LANDSCAPE AND VISUAL REBUTTAL

**OF BRIAN JOHN DENNEY BA (HONS), DIPLA, FLI, CENV,
MIEMA**

**AN OUTLINE PLANNING APPLICATION FOR THE
ERECTION OF UP TO 85 RESIDENTIAL DWELLINGS
(*REDUCED FROM 93 ORIGINALLY*) AND OPEN SPACE
(17/04673/OUT)**

**LAND AT JUNCTION WITH CARR ROAD, HOLLIN BUSK
LANE, SHEFFIELD, S36 1GH**

VIEW S3

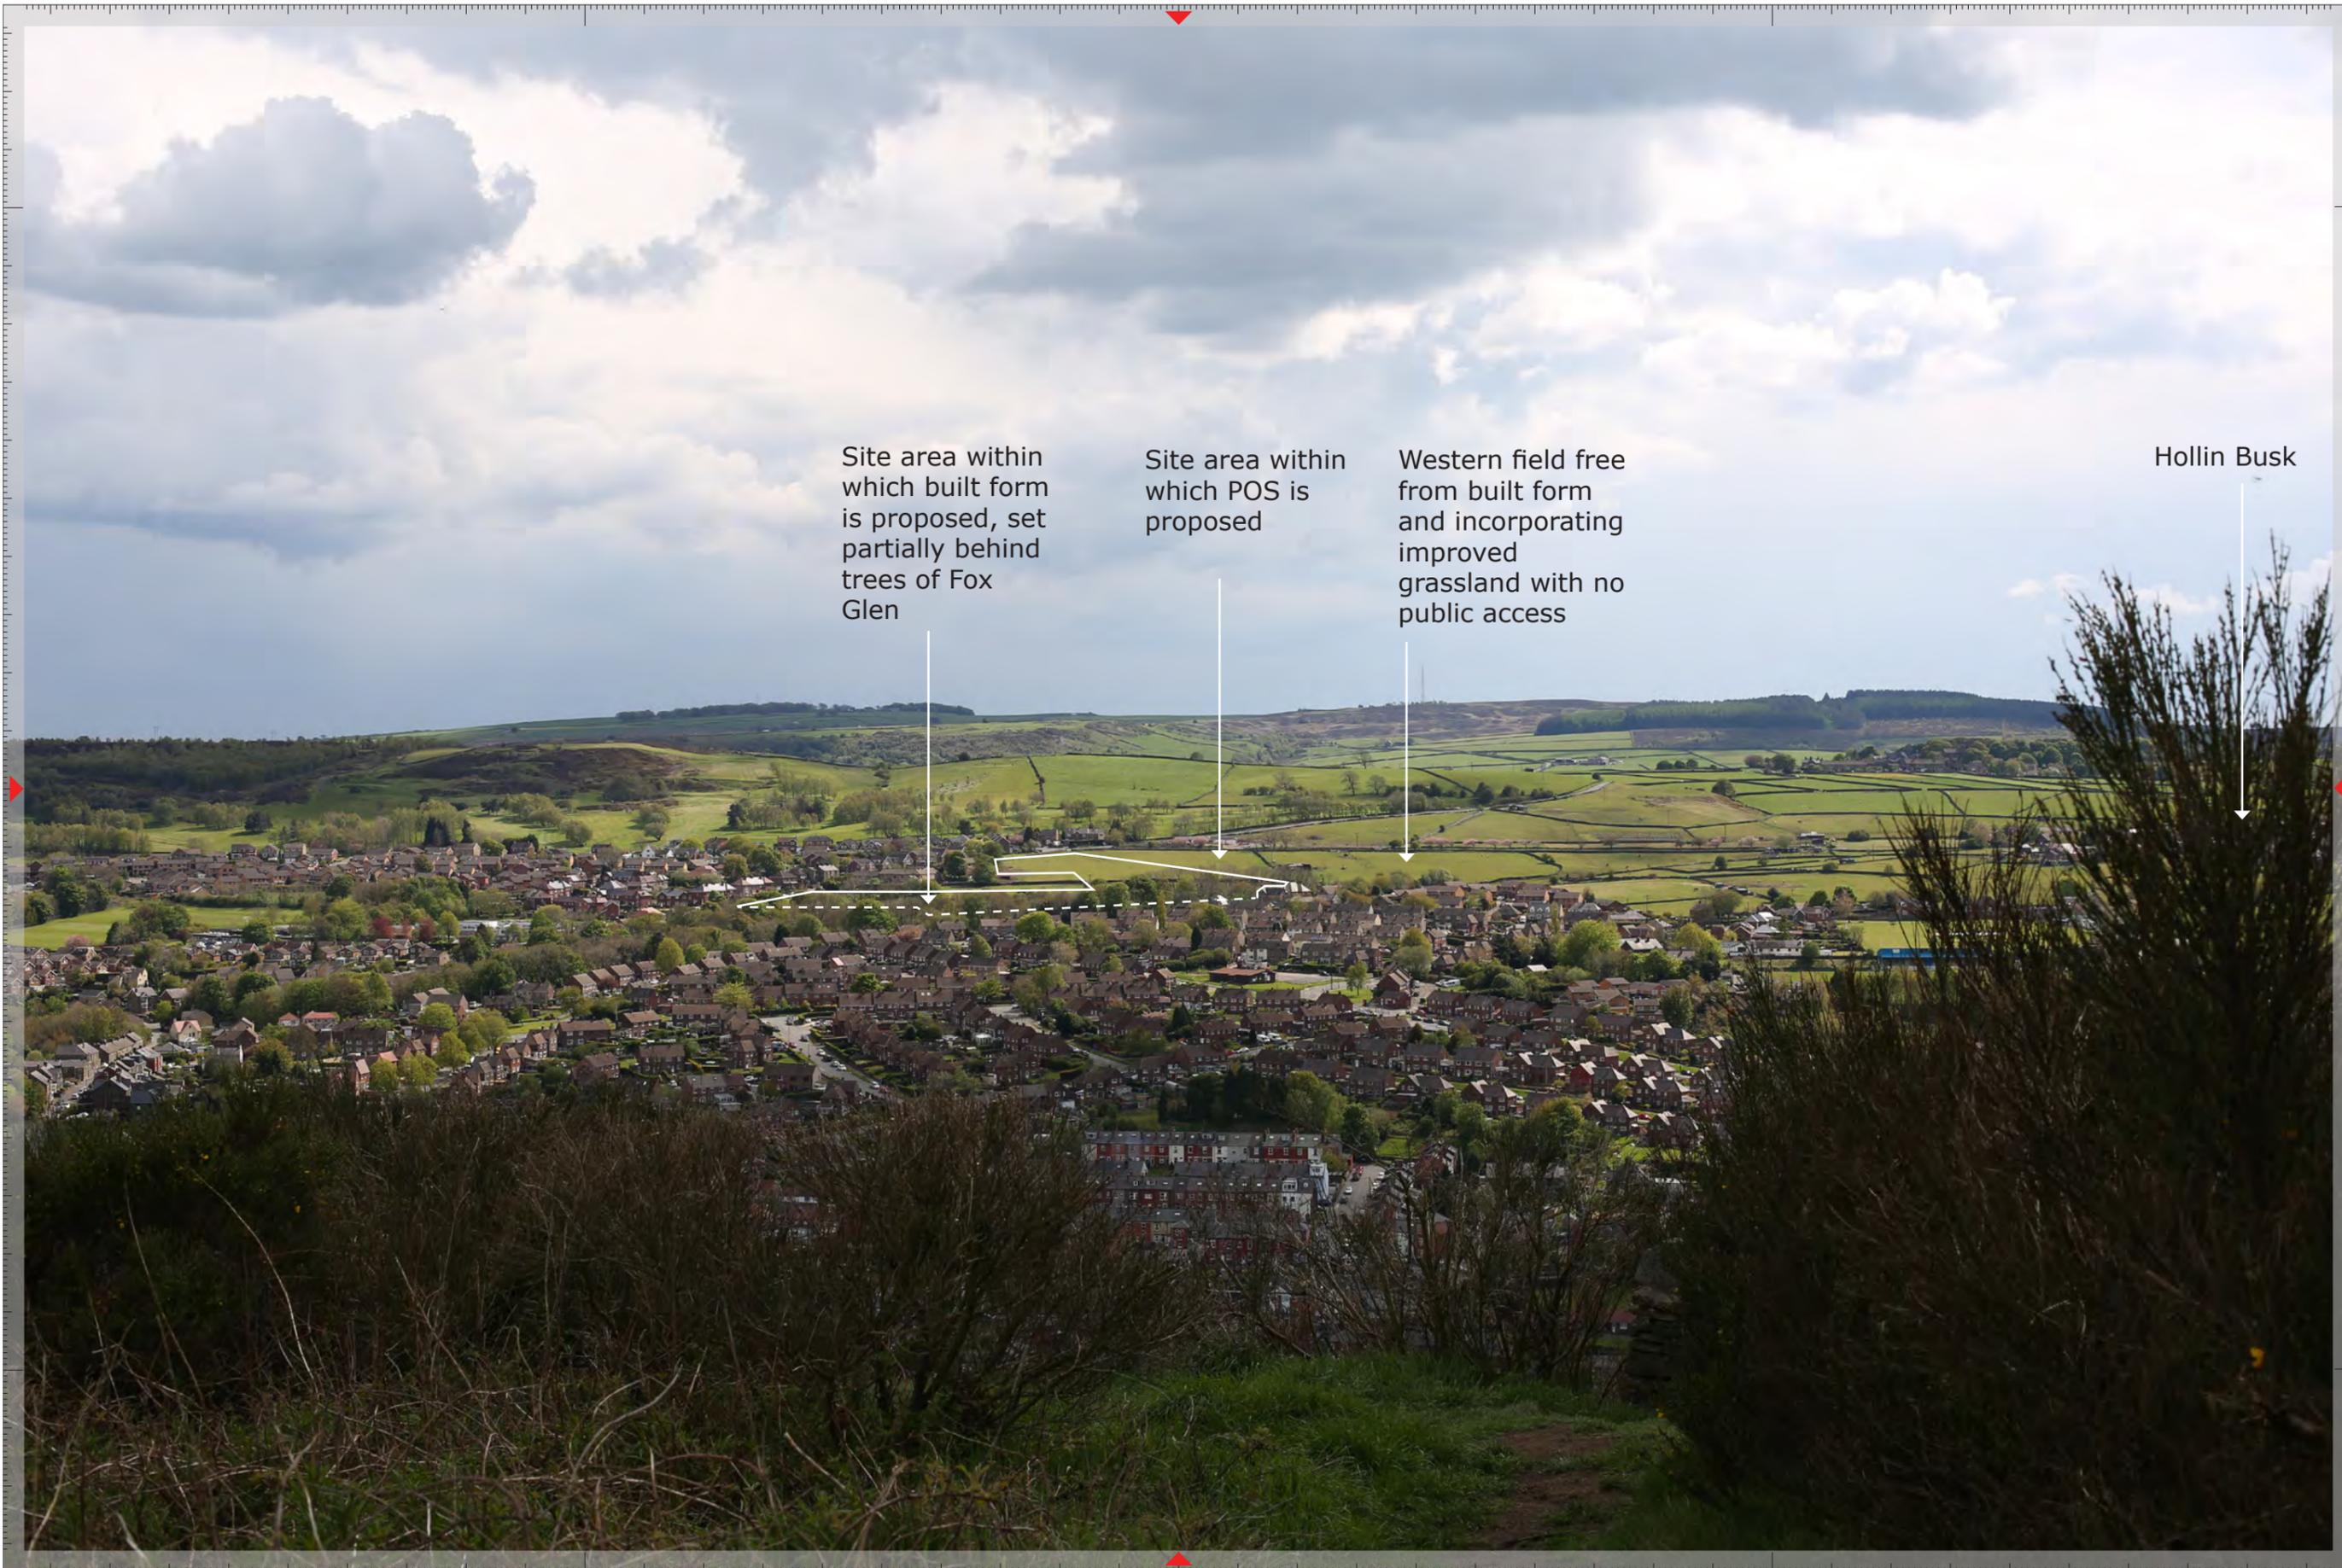
Above is Mr Ares' Photo from his viewpoint S3, to which I have added four annotations and a white outline of the area of proposed built form (dashed where set behind trees).

My photo from Mr Ares' viewpoint S3 with my annotations and a white outline of the area of proposed built form (dashed where set behind trees).

VIEW S4

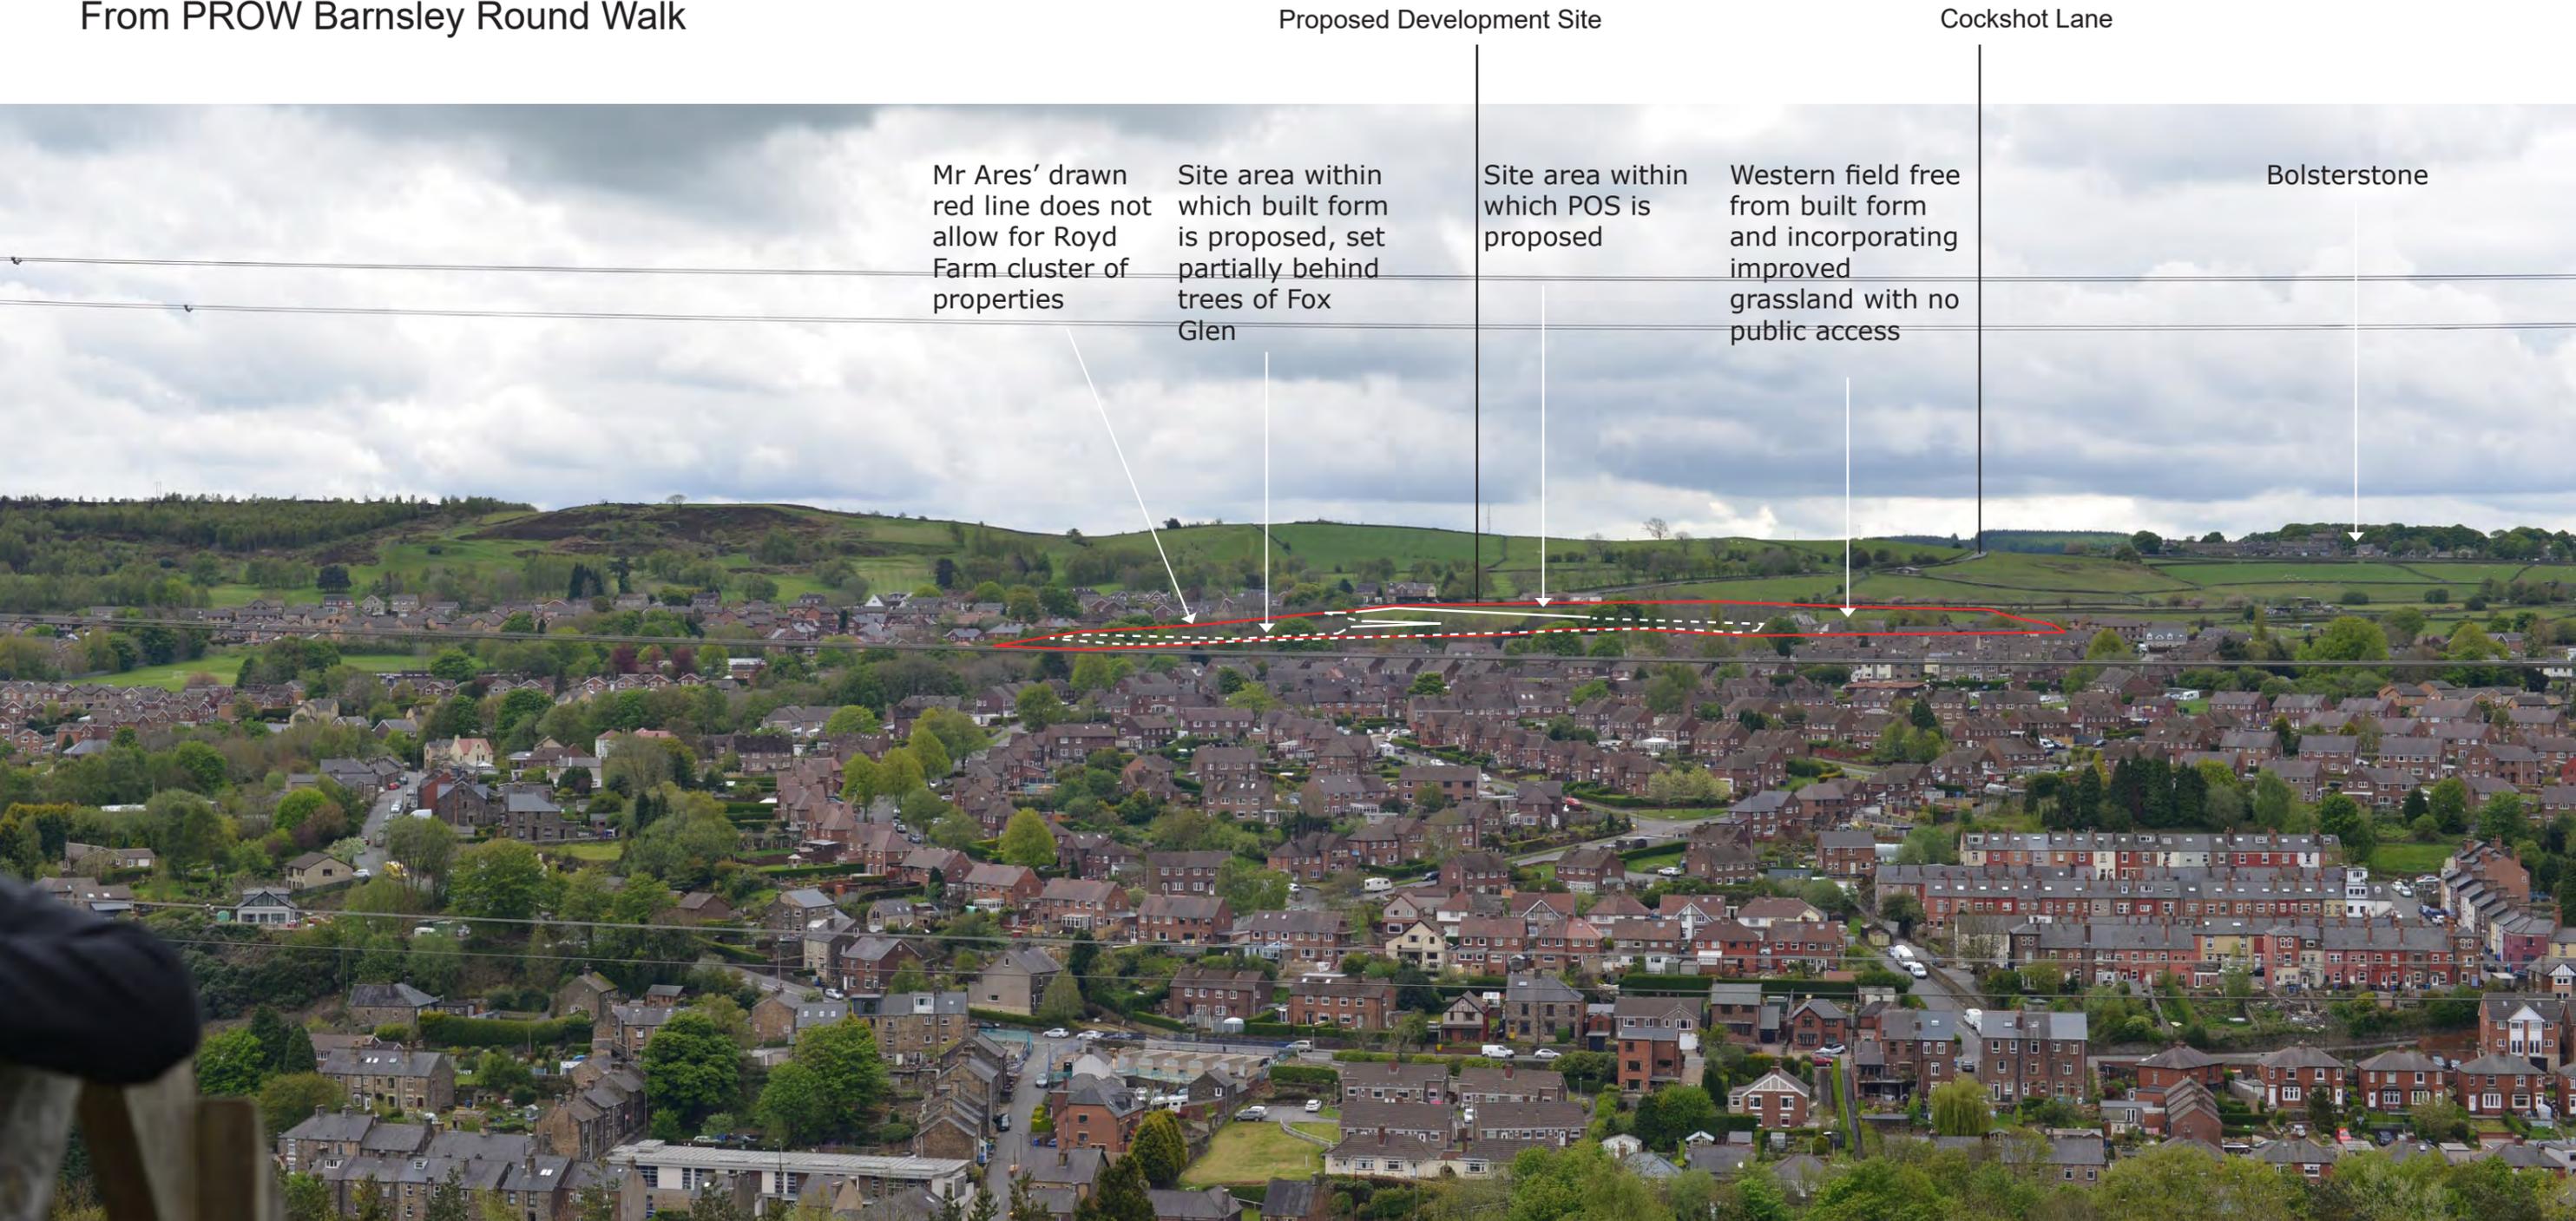
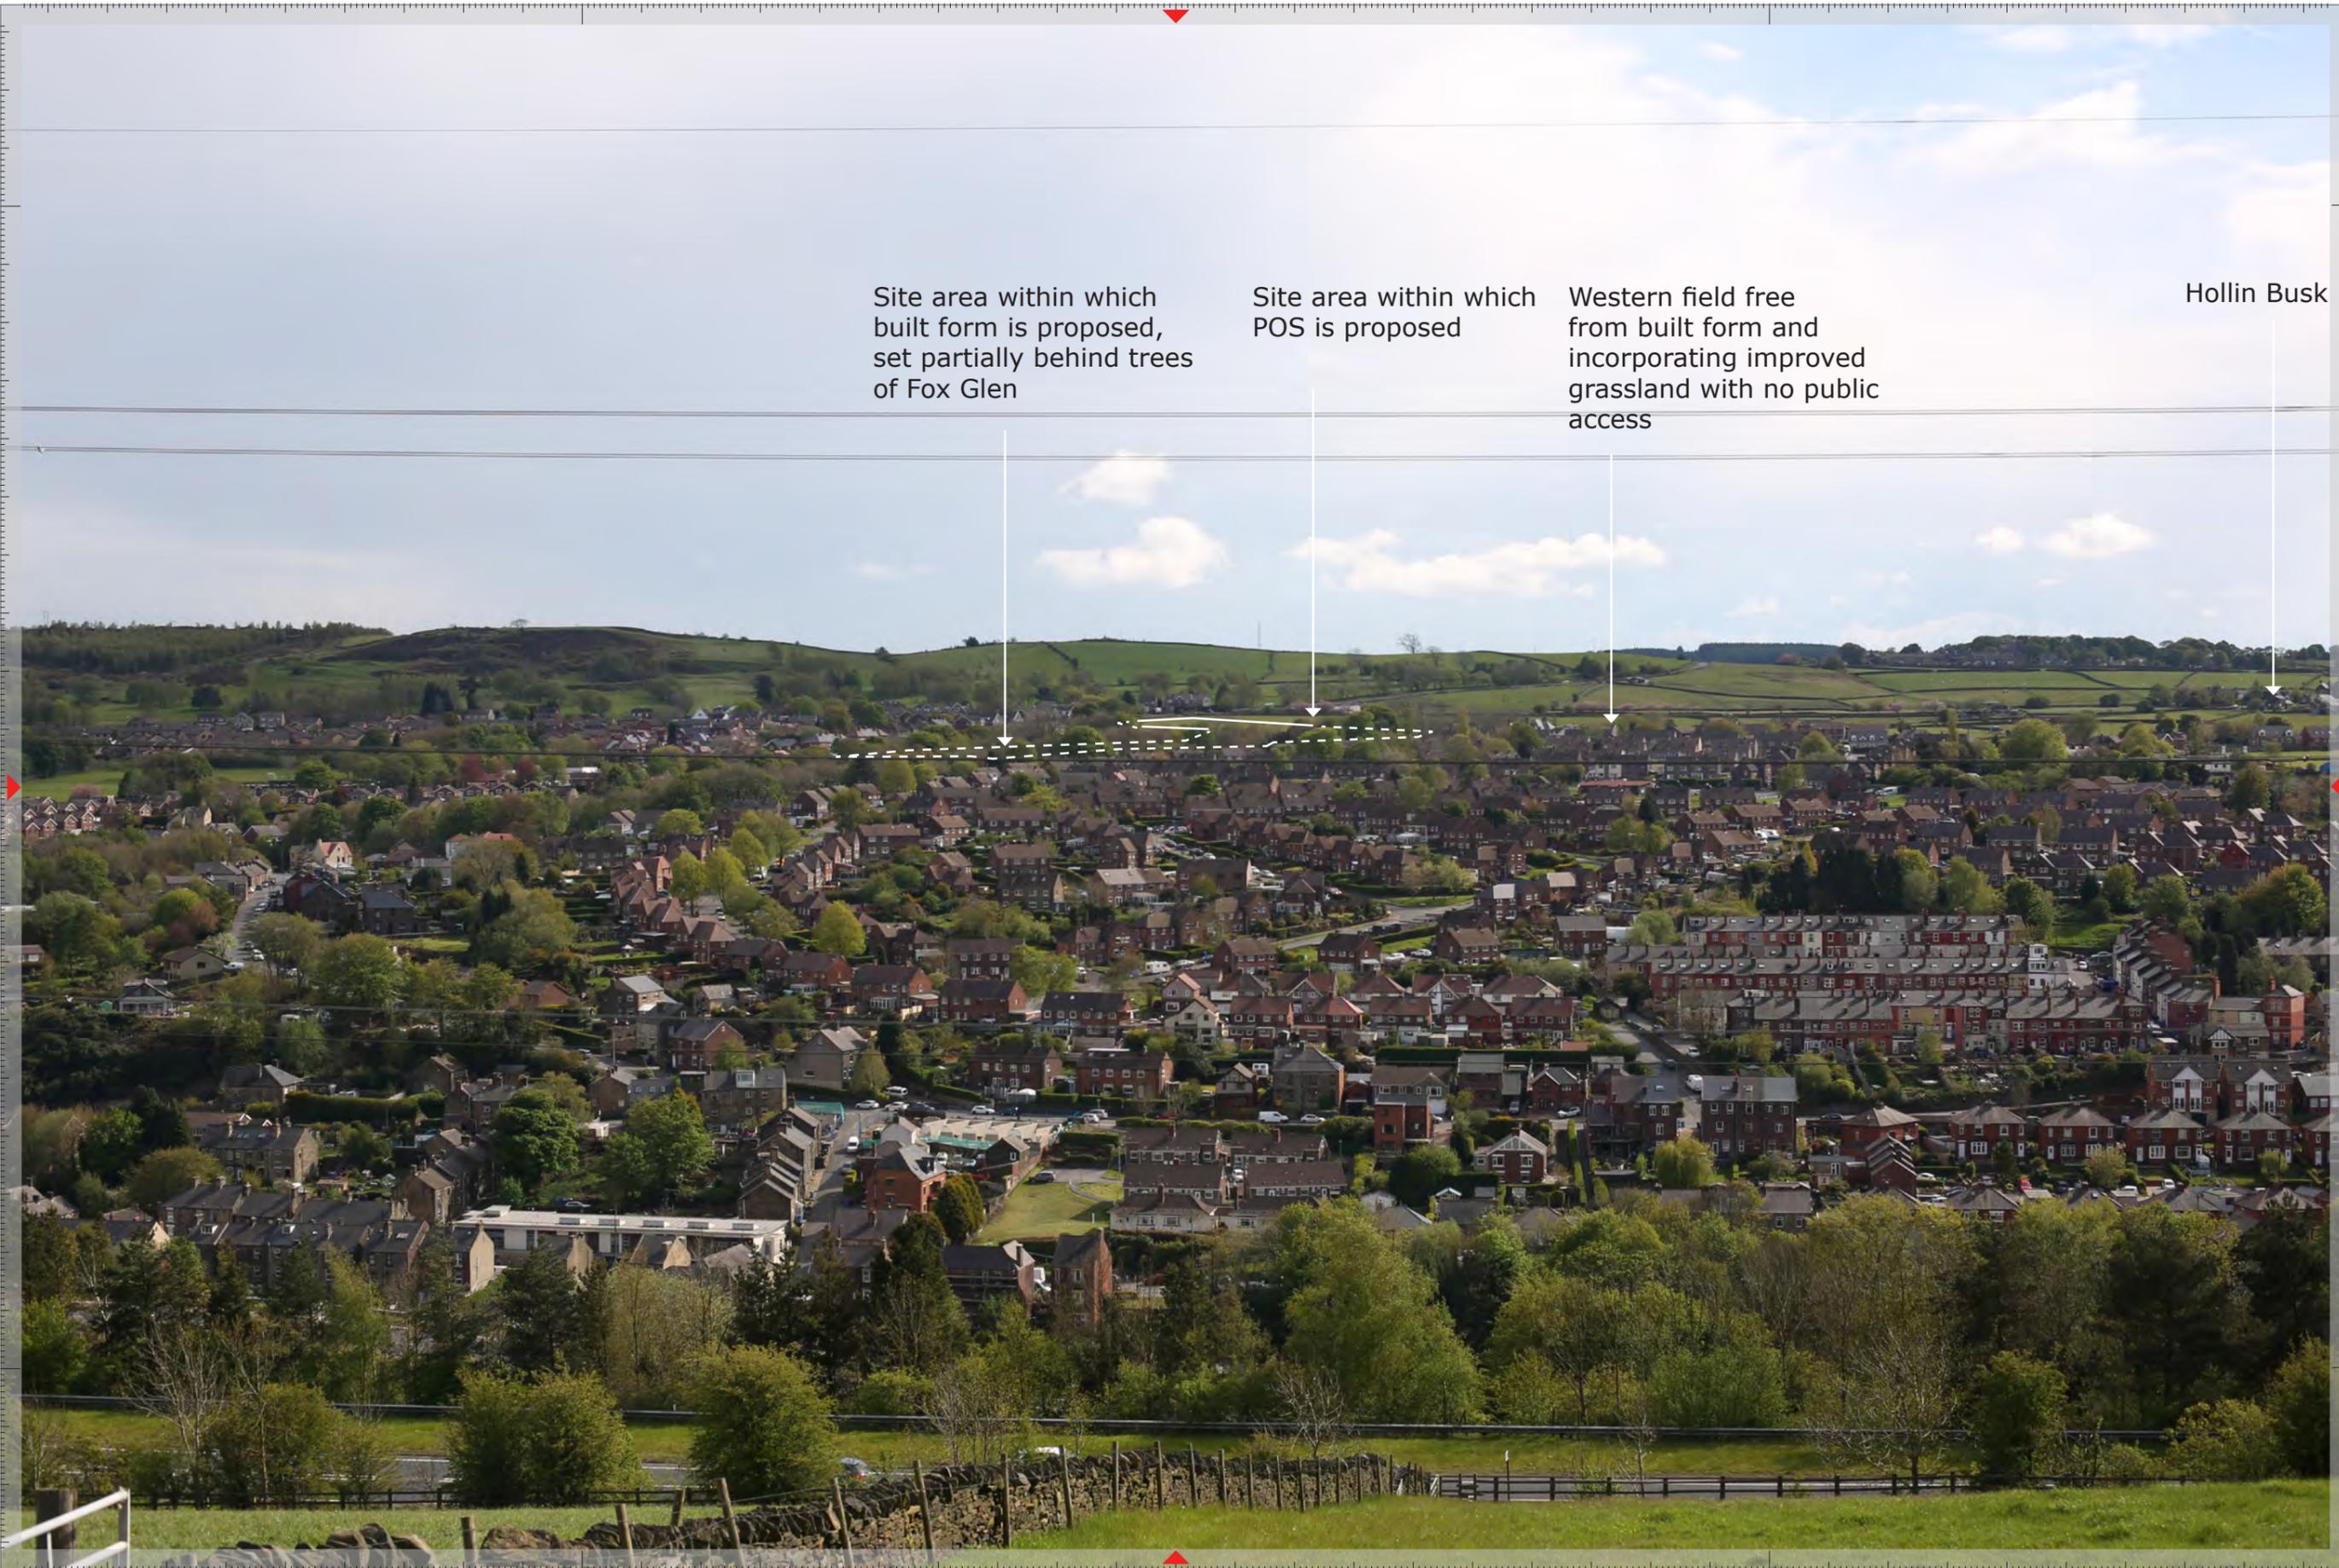
Mr Ares' drawn red line does not allow for Royd Farm cluster of properties

Above is Mr Ares' Photo from his viewpoint S4, to which I have added five annotations and a white outline of the area of proposed built form (dashed where set behind trees).
